bushfire protection assessment addendum

Proposed Residential Aged Care Facility
Lot 3 DP 805710
181 Forest Way, Belrose

November 2019
(Ref: 18MORR02)

Figure 3.3: Turning head dimensions
(source: Morrison Design, 2019)

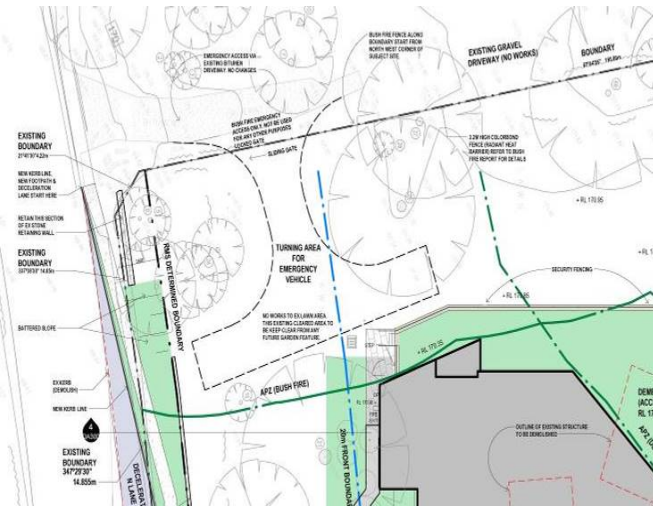
Council comment: Previous DA2017/0697 was recommended for refusal based on potential impacts to known individuals of *Grevillea caleyi* (Critically Endangered) within the road reserve immediately north of the property.

Bushfire Consultant to include a short statement justifying the turning area and confirming no trees / vegetation will be requiring pruning or removal.

In addition, Council had concerns that the area may be used for access outside of emergency situations. A compatible locked (RFS) gate will be included in the amended proposal to prevent this situation. The proposed gate is depicted in the site plan prepared by *Morrison Design* (refer Figure 3.3) as a sliding gate.

Travers bushfire & ecology can confirm that no further clearing will be required within the adjoining road reserve to the north or within the site to implement or utilise the existing access driveway. The following figure depicts the location of the *Grevillea caleyi* within the adjoining land.

As depicted in Figure 3.2 above, the *Grevillea species* is located at the entry to the road to the north. The existing unformed road has a width of 3.5m. The only portion of this existing road proposed to be used as a secondary emergency access point is the first 20m length before the turning head is provided on site. *Planning for Bush Fire Protection (PBP)* allows for some short restrictions in access where they are not less than 3.5m and extend for no more than 30m and where the obstruction cannot be reasonably avoided or removed. The existing unformed road does not require any further clearing to provide sufficient access for fire fighting vehicles and therefore there will be no impact on the *Grevillea sp.*

In addition, the proposed turning area within the property has been located to ensure no impact on existing vegetation. Confirmation from engineers is required to ensure that the existing ground surface is capable of carrying fully loaded firefighting vehicles of 15 tonnes. Alternatively, *grass-crete* (capable of supporting 15 tonnes) can be used to minimise environmental impact.
